ADDENDUM #1

Reference: Tie Fork Visitor Service Center
Utah Department of Transportation - , Utah
DFCM Project No. 08264900

Tie Fork Visitors Service Center Demolition of Existing Structures

DFCM Project # 08264000

7: Site plan with boundaries of the demolition.

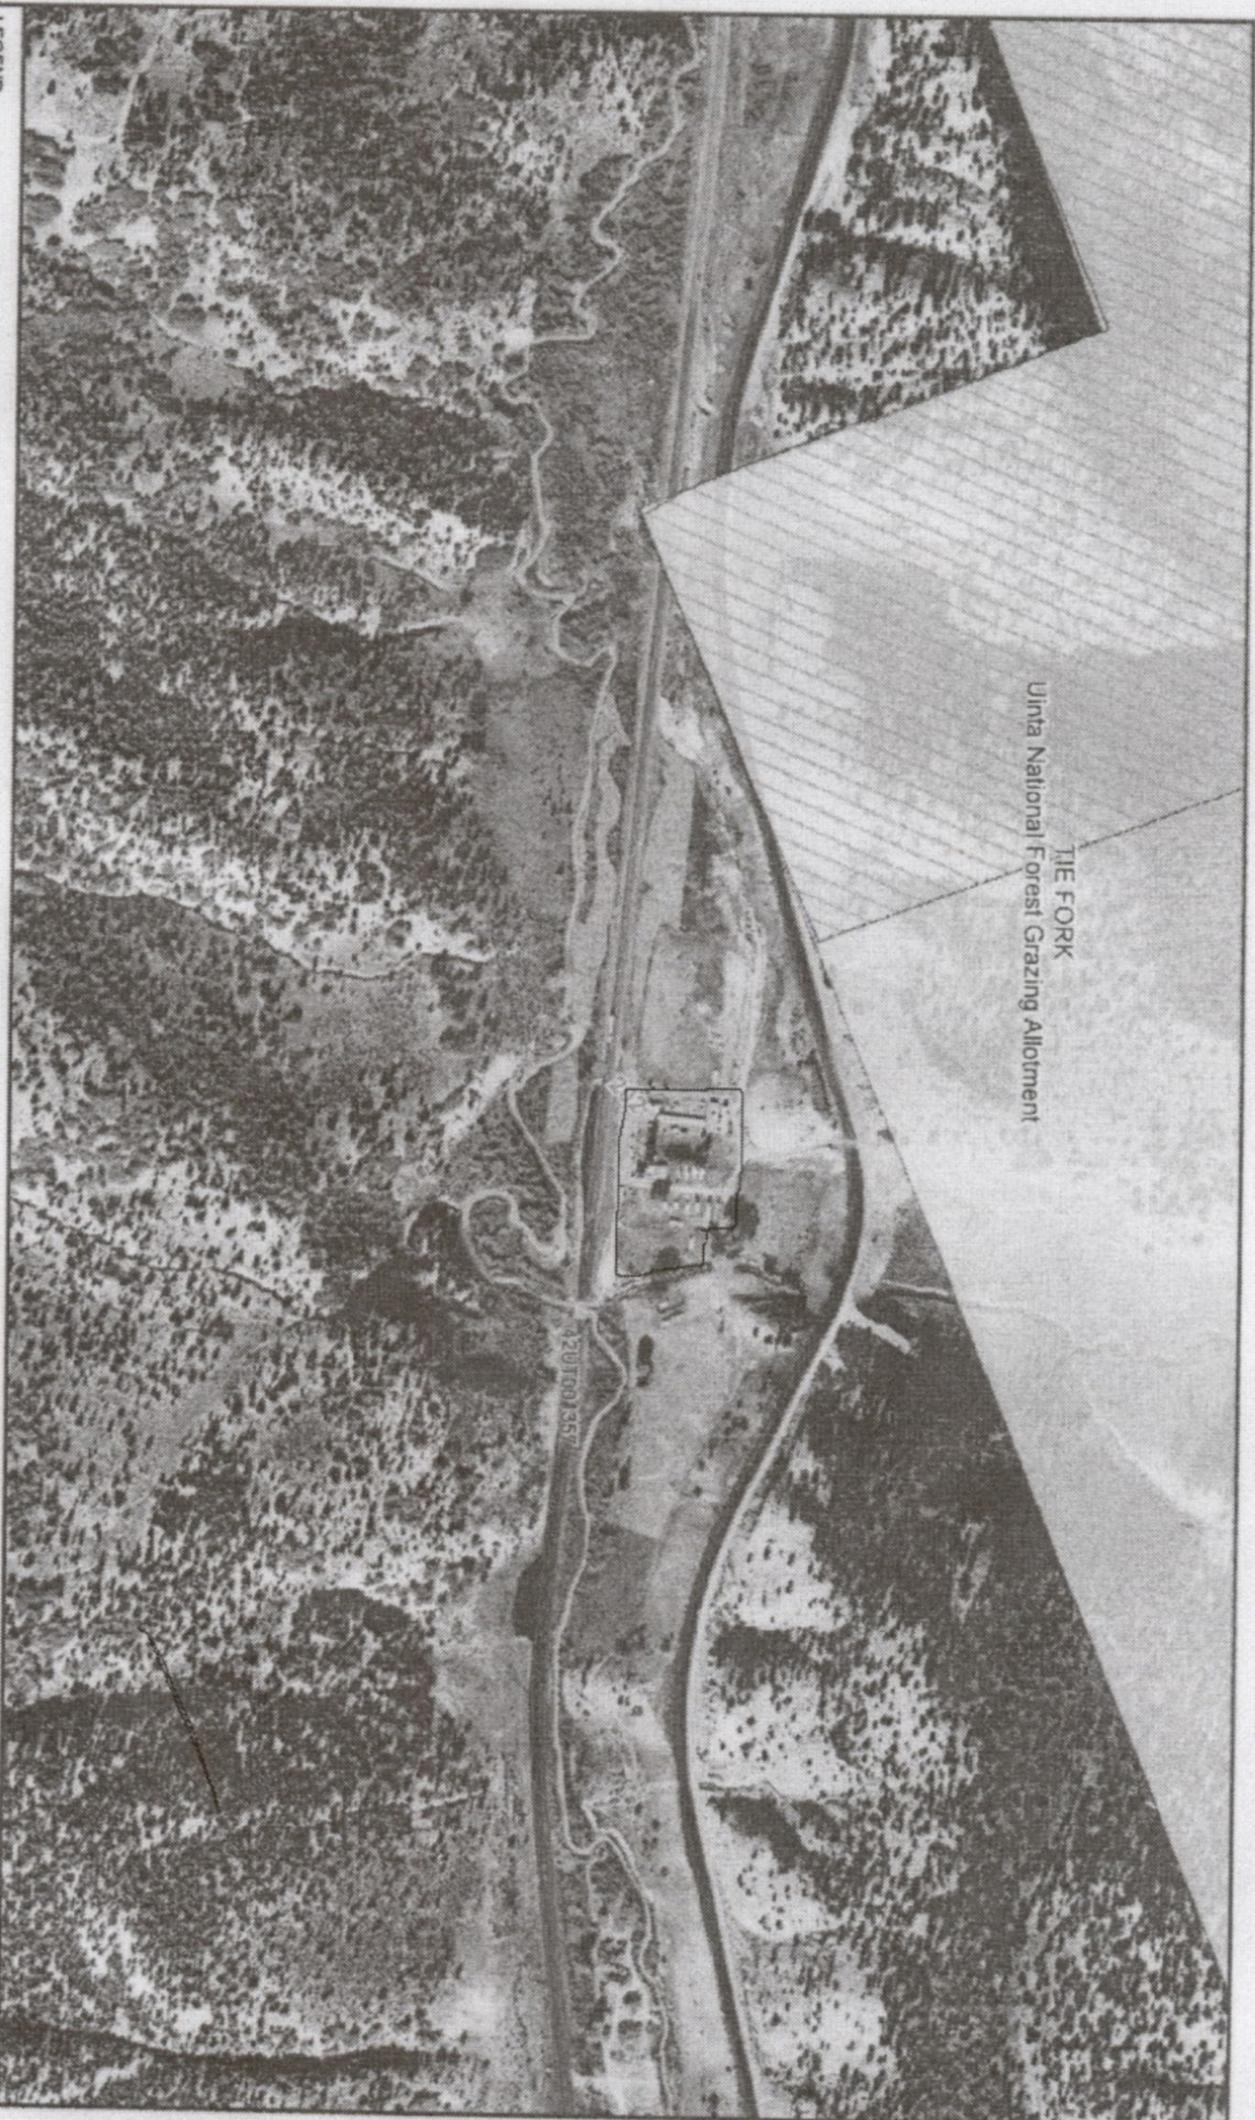
5: Boundaries of the demolition site.

North: wooden fence and t-post wire fence to include both fences.

South wooden fence to include the fence.

West: wooden stakes. Dividing line between wet-lands and demolition site.

East: wooden fence with the jog to the east to include the fence.
